ADDENDUM NO. 1

SUBJECT: Solicitation No. X009A

TITLE: Miami-Opa Locka Executive Airport (OPF) Runway 09L-27R Rehabilitation

1 ALTERNATE DRYWELL
N503 SCALE: N.T.S.

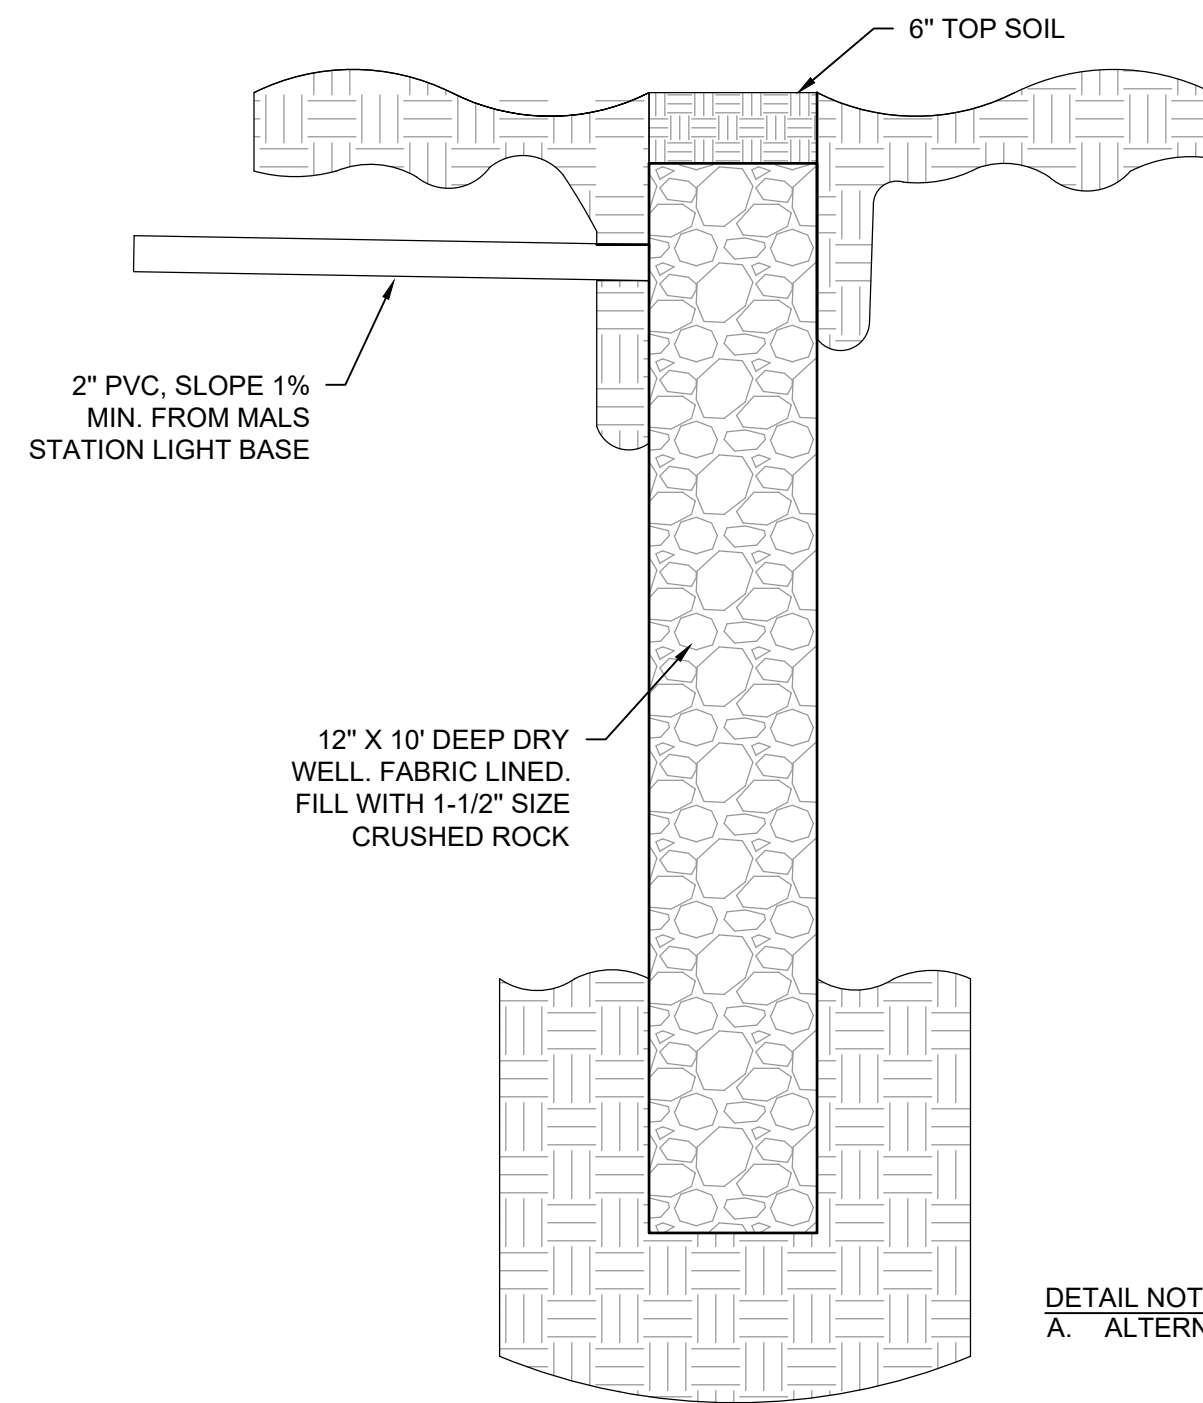
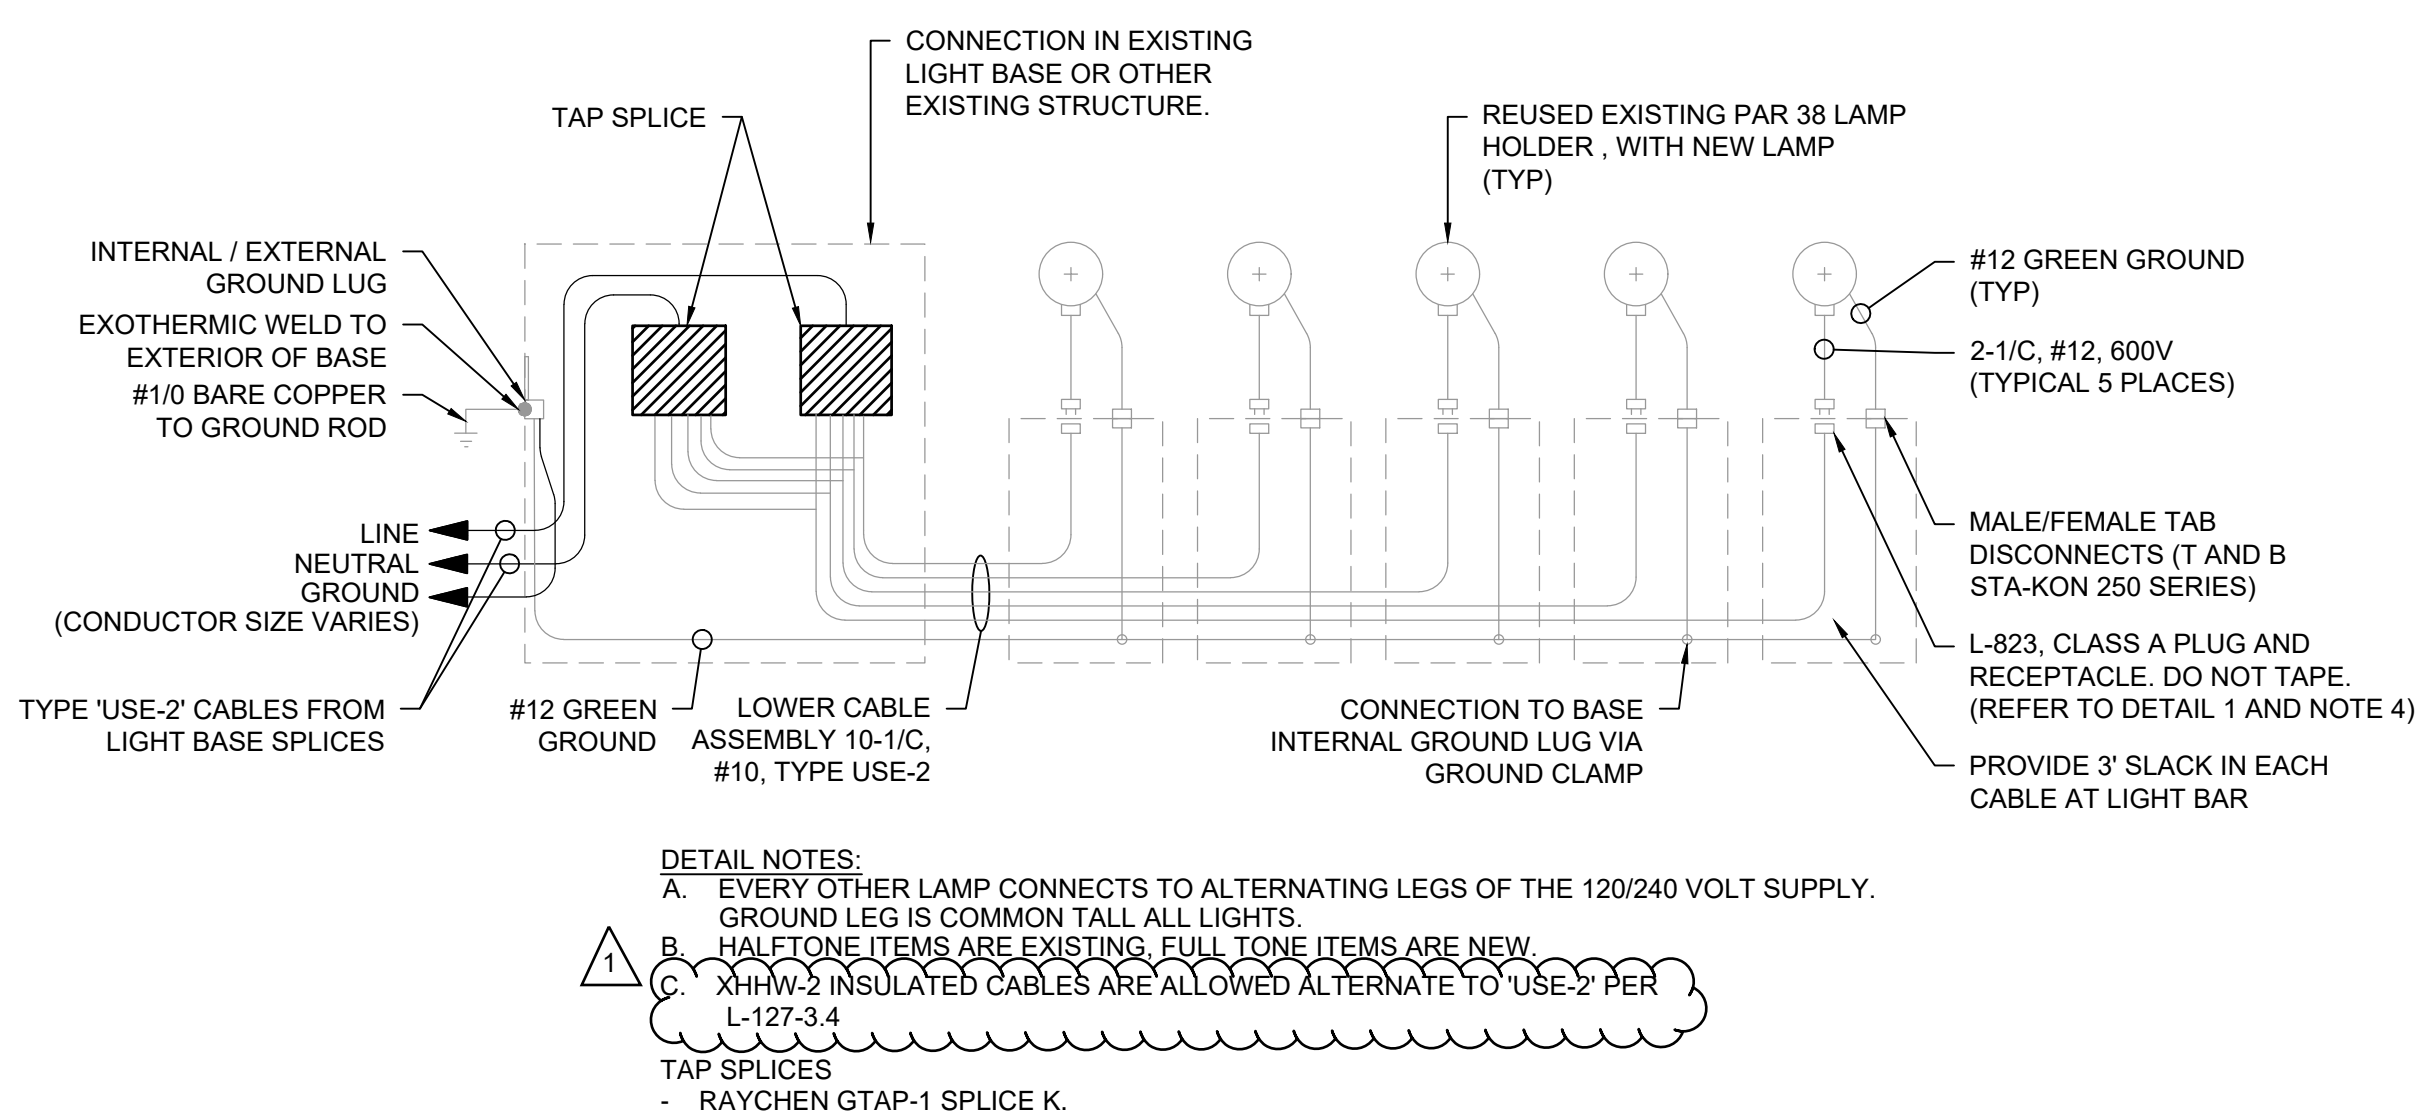
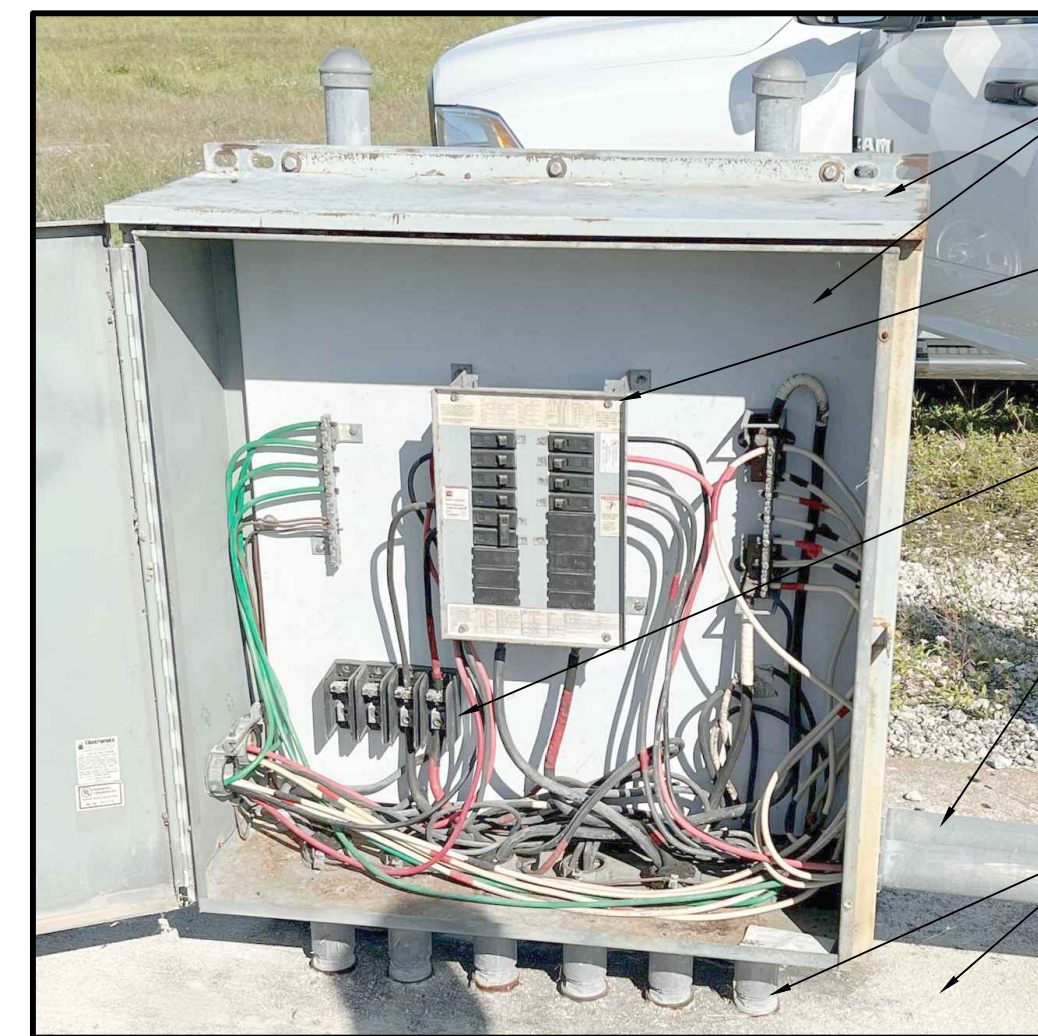
Question No. 49 Specification L-127, DWG N501 and DWG N503 – Specification L-127-3.4 calls for underground cable to be XHHW-2 insulation. However, details on drawings N501 and N503 calls for USE-2 insulation. Please clarify if XHHW-2 insulation is acceptable in lieu of USE-2 insulation.

Answer No. 49 XHHW-2 insulated cables are an allowed alternate to USE-2 in this case. Refer to drawing N501. Refer to Attachment 4 of Addendum No. 1 – Construction Plans & Drawings REVISED, Sheets N501 & N503.

E401

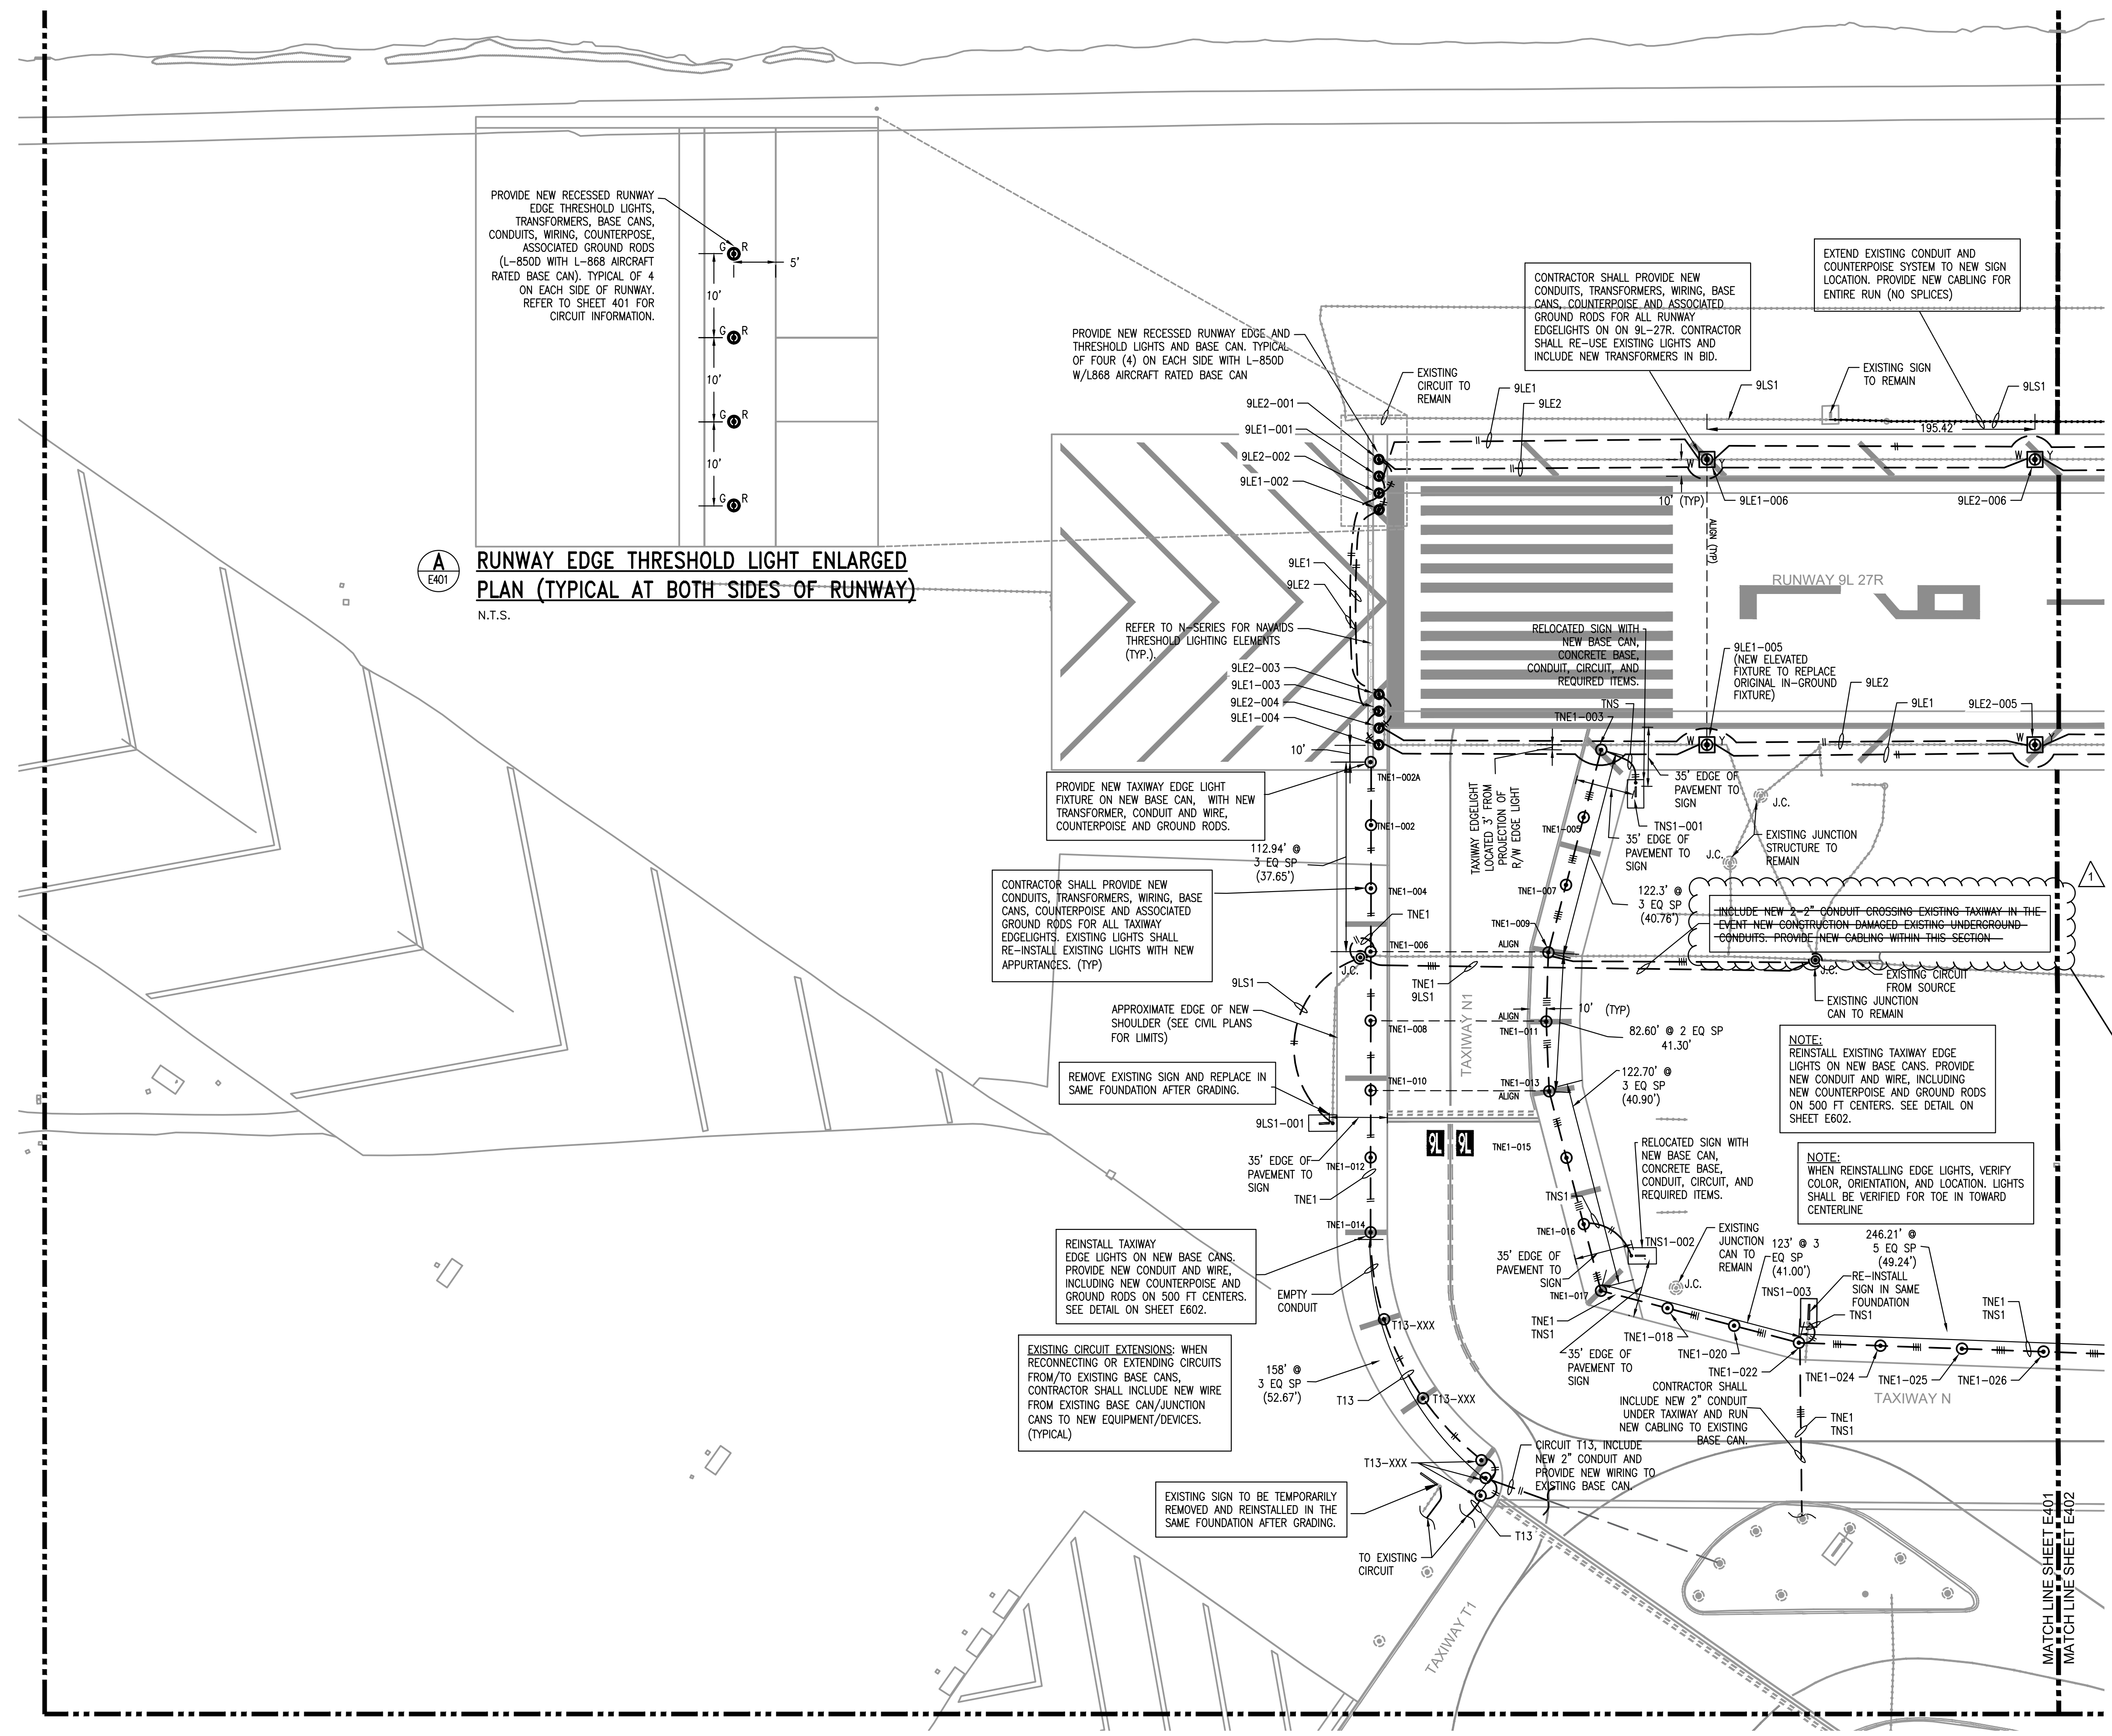
Question No. 50 DWG E401 – Please confirm that 3 – 2” PVC conduits will be added to the existing junction can shown on E401.

Answer No. 50 New 2-2” conduit crossing existing taxiway to replace existing underground conduit. Provide new cable within this section. These new conduits are to be tied to the junction boxes as shown on plans. Refer to Attachment 4 of Addendum No. 1 – Construction Plans & Drawings REVISED, Sheet E401.

C TRENCH SECTIONS FOR UNDERGROUND
N.T.S.

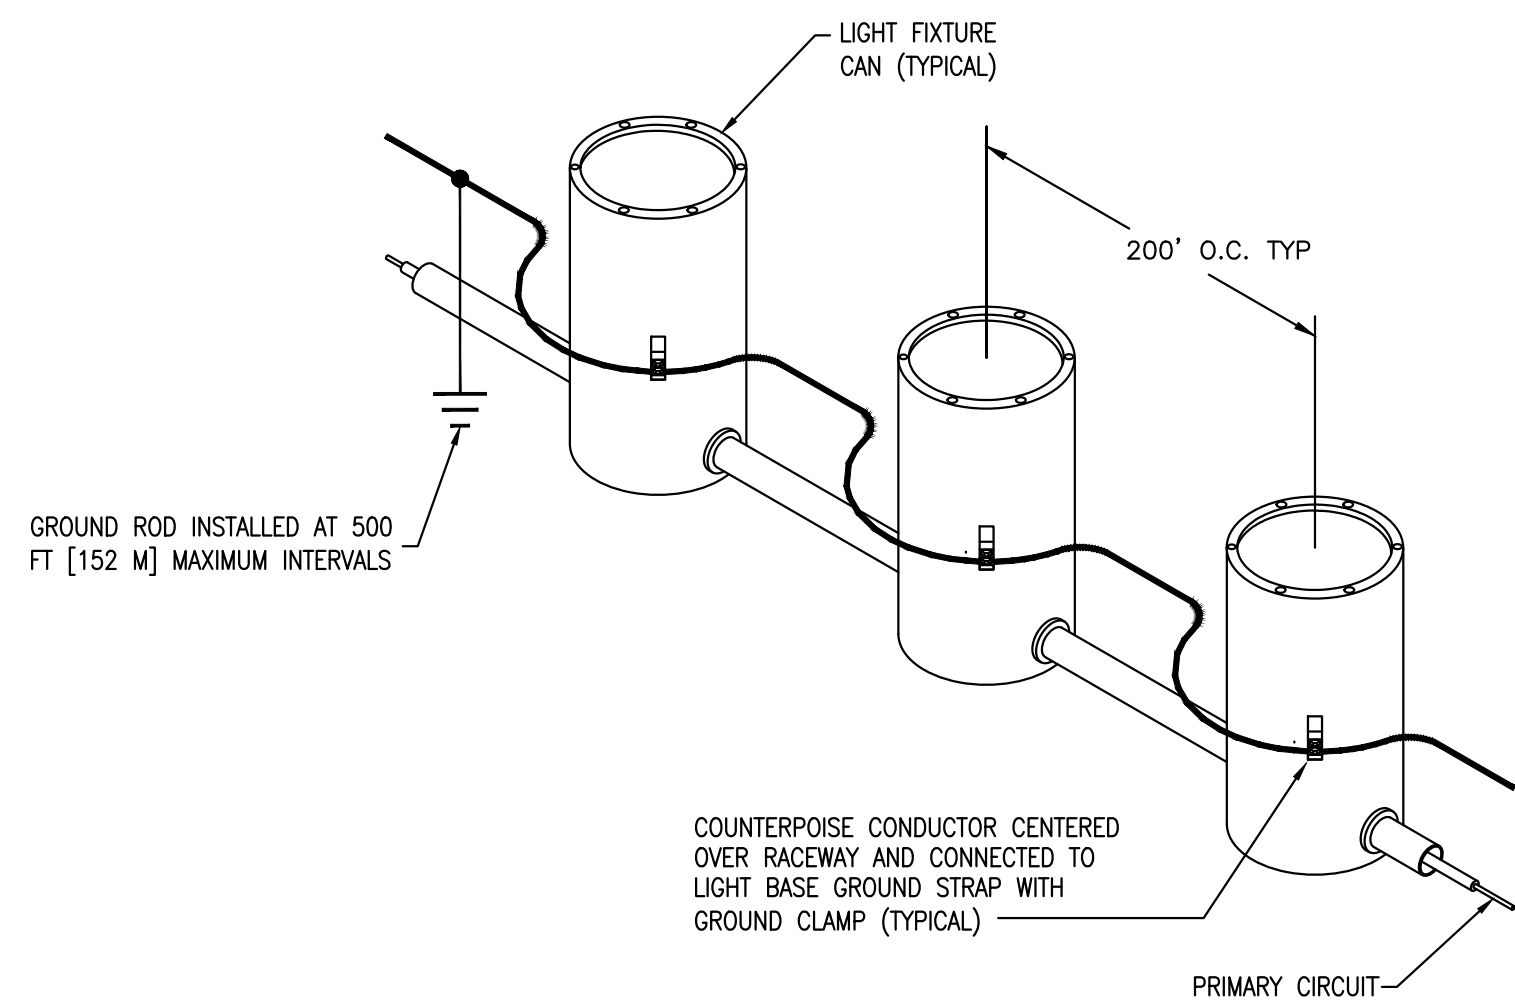
Question No. 58 DWG E301 through E308 – Please clarify what type of material will be used to fill the void of the conduits and base cans that are being removed/demolished under existing paved shoulders.

Answer No. 58 When not filled by the P-610 concrete for ductbanks and base cans, contractor may use P-153 Controlled Low-Strength Material (CLSM), to restore trenches and voids left by the removal of the existing conduits, base cans and all other removed structures under runway, taxiways, and shoulders. Restoration is required up to the bottom of the new pavement section. This work is incidental under pay item L-100-5.1. Refer to Attachment 4 of Addendum No. 1 – Construction Plans & Drawings REVISED, Sheet E602.

NOTE:
WHEN NOT FILLED BY THE P-610 CONCRETE FOR DUCTBANKS AND BASE CANS, CONTRACTOR MAY USE P-153 CONTROLLED LOW-STRENGTH MATERIAL (CLSM), TO RESTORE TRENCHES AND VOIDS LEFT BY THE REMOVAL OF THE EXISTING CONDUITS, BASE CANS AND ALL OTHER REMOVED STRUCTURES UNDER RUNWAY, TAXIWAYS AND SHOULDERS. RESTORATION IS REQUIRED UP TO THE BOTTOM OF THE NEW PAVEMENT SECTION. THIS WORK IS INCIDENTAL UNDER PAY ITEM L-100-5.1.
